Re: Freeport-McMoRan Chino Mines Company –
Permit GR009RE Technical Comments on
Revision Application 18-1 for the Updated Closure Closeout Plan

Freeport-McMoRan Chino Mines Company (Cobre) submitted an update to Chino's Closure Closeout Plan (CCP) on February 14, 2018. The Mining and Minerals Department (MMD) in a letter dated June 18, 2018 requested Chino to respond to agency and public review comments. Where the comments included multiple questions within a paragraph, and in the hope that the response will be easier to track, the response is often located directly below the comment. The comments are listed in italics, followed by Chino's responses.

CLIENT FREEPORT-McMORAN CHINO MINE COMPANY BAYARD, NEW MEXICO		
PROJECT CLOSURE/CLOSEOUT UPDATE		
TITLE POST MINING LAND USE AND WAIVER AREAS IN THE NORTH MINE AREA		
CONSULTANT	YYYY-MM-DD	2017-06-01
	PREPARED	CM
	DESIGN	TS
	REVIEW	TS
	APPROVED	TS
PROJECT No 11301153	PHASE 6	Rev 0
		FIGURE 8-1

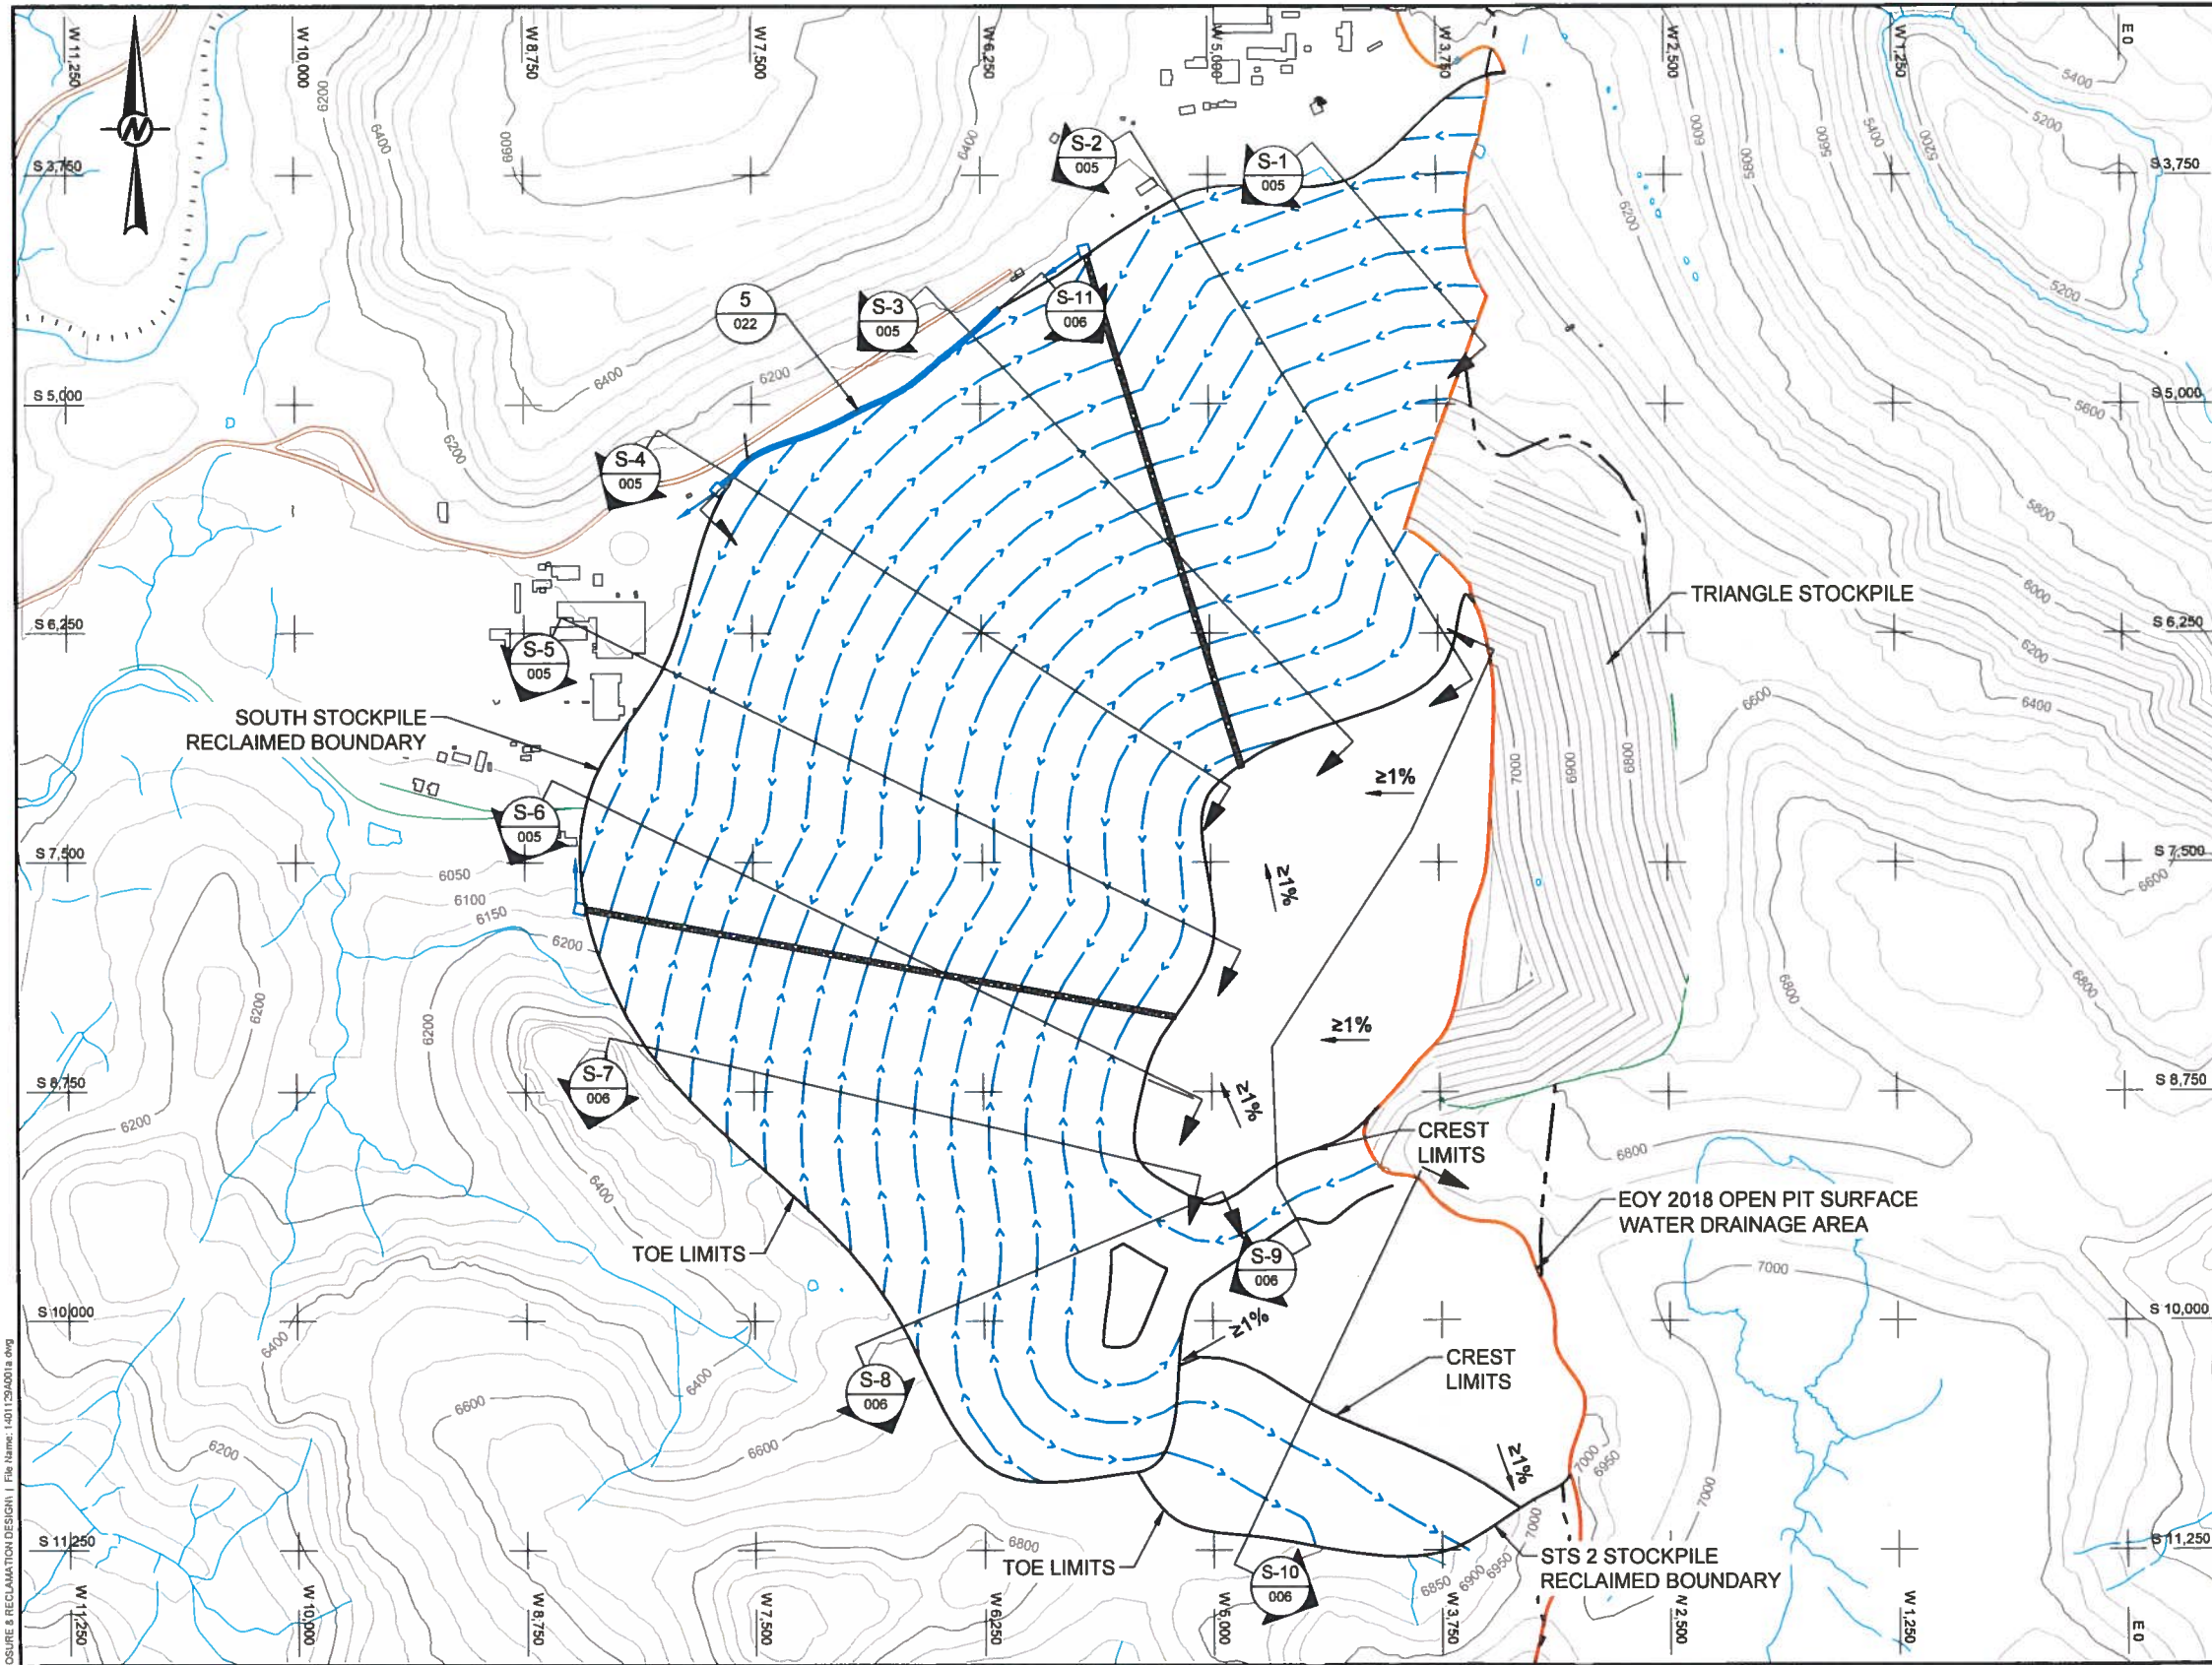
4. *Page 34-35, Section 5.1.3. The CCP indicates that Chino will update the MMD waiver during or after MMD review. Page 34 states that due to mining, 'portions of the open pit lie outside the geographic area defined when the conditional waiver was granted in 2003.' Please propose adjustments to the 2003 MMD waiver to become consistent with the 2018 Updated CCP. This might best be provided in one comprehensive figure showing:*
 - *the waiver area pursuant to Mining Act Rules*
 - *the area of open pit hydraulic containment (AOPHC)*
 - *the open pit surface drainage area (OPSDA).*

15. *Figure 8-1 PMLU designation at mine site. Chino should clarify whether its design includes the boundaries between unreclaimed (waived) and reclaimed for PMLU of wildlife habitat. For example, will these locations include some combination of berms, fencing, drainage ditch, rock armor or other design elements?*

Thanks for your comments. Please see the attached revised Figure 8-1 which shows the original 2003 waiver area, the proposed End of Year 2018 expanded waiver area, the open pit capture zone (OPCZ), and the OPSDA.

Some berms and channels may be useful between reclaimed and unreclaimed facilities; however, this is a final design detail that is not warranted to specify at a conceptual level and so Chino has not included these features and they will be captured in the contingency of the estimate.

TITLE
**SOUTH STOCKPILE, STS2 STOCKPILE AND TRIANGLE
 STOCKPILE GRADING AND DRAINAGE PLAN**

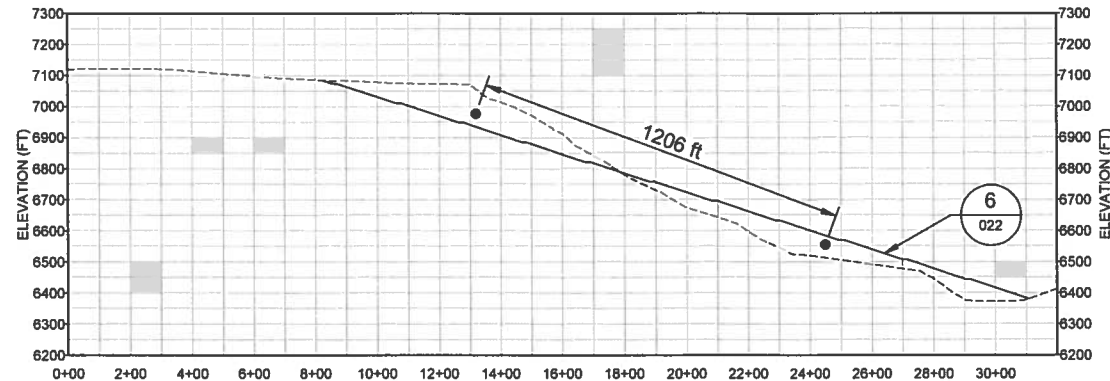
6. *Please define the anticipated slope direction(s) and grade of the top surface of the STS2 Stockpile at closure (see Figure 004 in Appendix A).*

The top surface will be graded to drain toward the constructed downdrains and ultimately to the exterior of the mine, in a general westerly/northwesterly direction. Figure 004 in Appendix A has been updated to show the slope direction and grade of the top surface of the STS2 Stockpile at closure and is attached to this response letter.

TITLE
NORTH MINE AREA BORROW LOCATIONS AND HAUL ROUTES

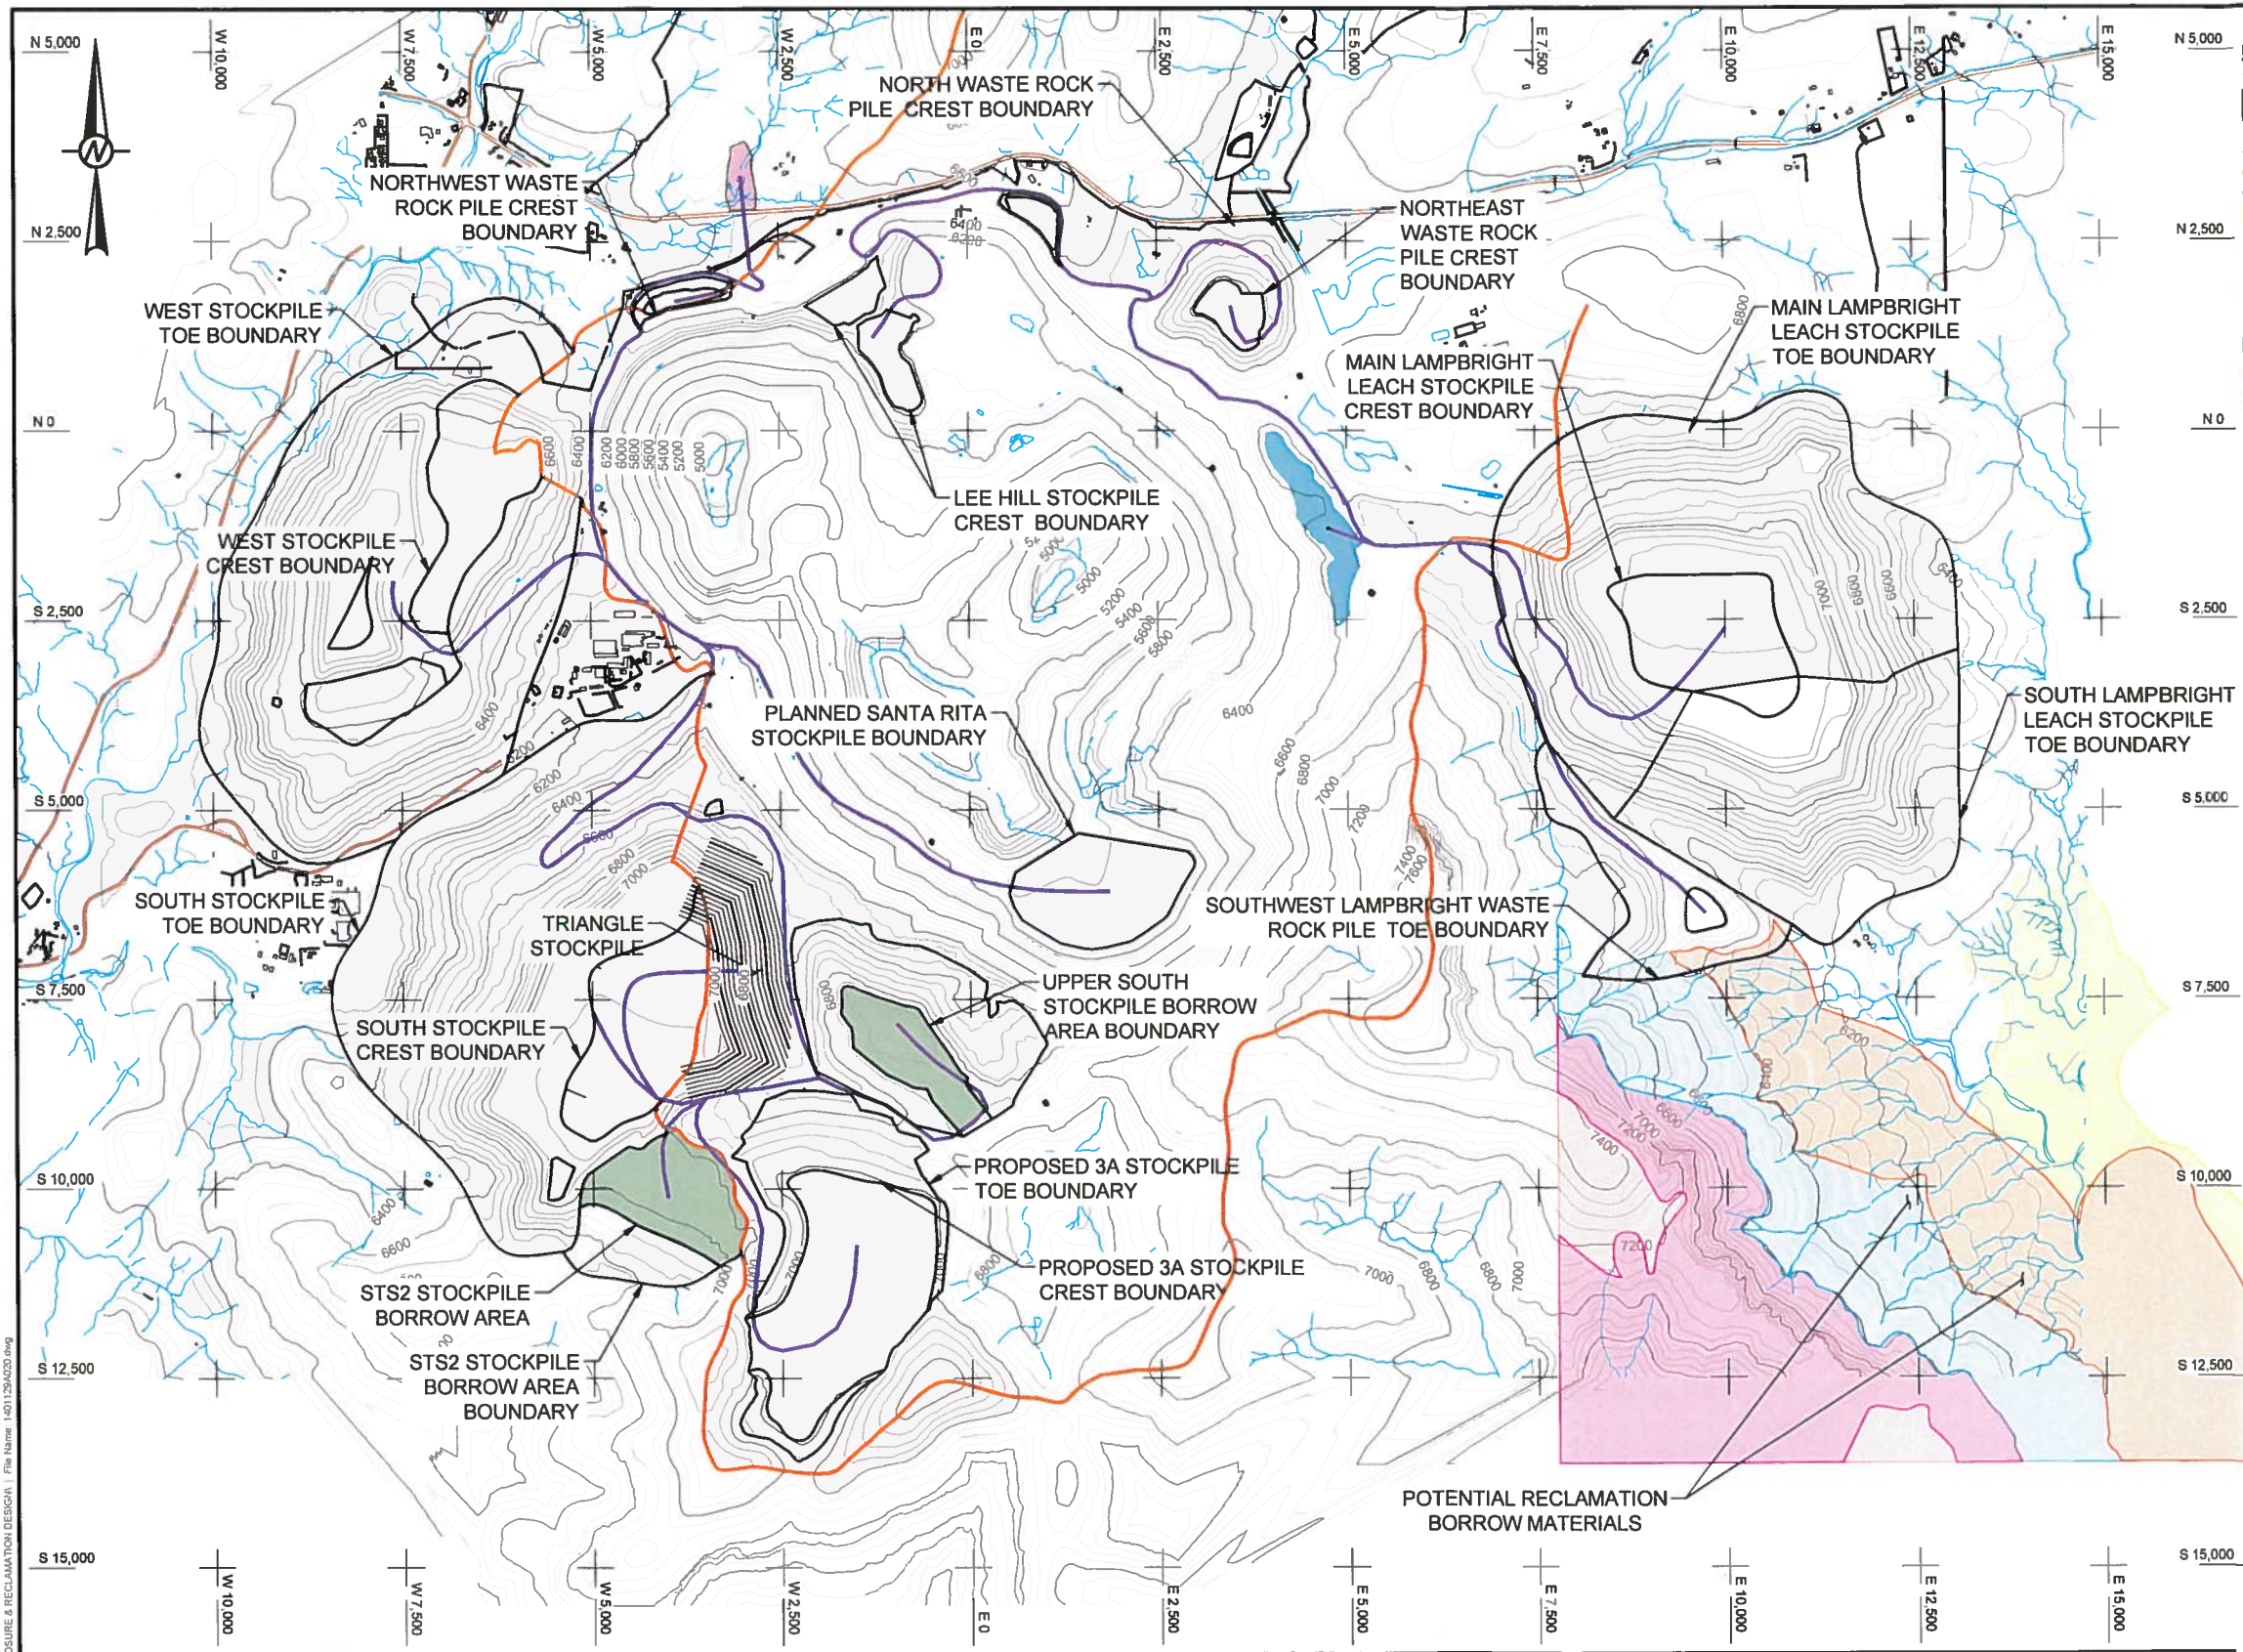
3. *Figure 021 identifies Rubio Peak Conglomerate, Rubio Peak Flows, Sugarlump Tuff, Bear Springs Basalt and Kneeling Nun Tuff as either potential cover borrow areas or riprap areas. Please note that for the CCP and financial assurance cost estimate, only Kneeling Nun Tuff and approved ACM material from the Upper South Stockpile, STS2 Stockpile and Whitehouse Stockpile shall be considered for reclamation. Material from the Rubio Peak Formation is currently being tested by Chino on a test plot and was conditionally approved by MMD for the North Lampbright Waste Rock Stockpile under Revision 16-1. However, the Rubio Peak Formation material is not approved for wider use at Chino on facilities such as Main Lampbright, South Lampbright, or Southwest Lampbright as currently proposed in the CCP. The haul routes depicted in Figure 021 should be modified accordingly for the cost estimate.*

Chino is disappointed in the MMD position taken above to limit the use of the conditionally approved Rubio Peak material for FA purposes. Preliminary results from the Rubio Peak demonstration plots shows that the material is on the right trajectory to meet the MMD and NMED cover material standards. Construction of the Rubio Peak test plots was completed in June 2018. Chino will collect data on these plots and present it to the agencies. It is already obvious that the material is a useful reclamation cover material and it is reasonable that any party reclaiming the site will take advantage of it. Chino will continue to list it as a potential reclamation cover source for various stockpiles, but for financial assurance estimating only use material approved by MMD. Chino has updated the material takeoff tables (see response to comment #2 above) and has updated the haul routes depicted in Figure 021 in Appendix A to reflect MMD's requested change in comment #3. Updated Figure 021 is attached to this response letter.
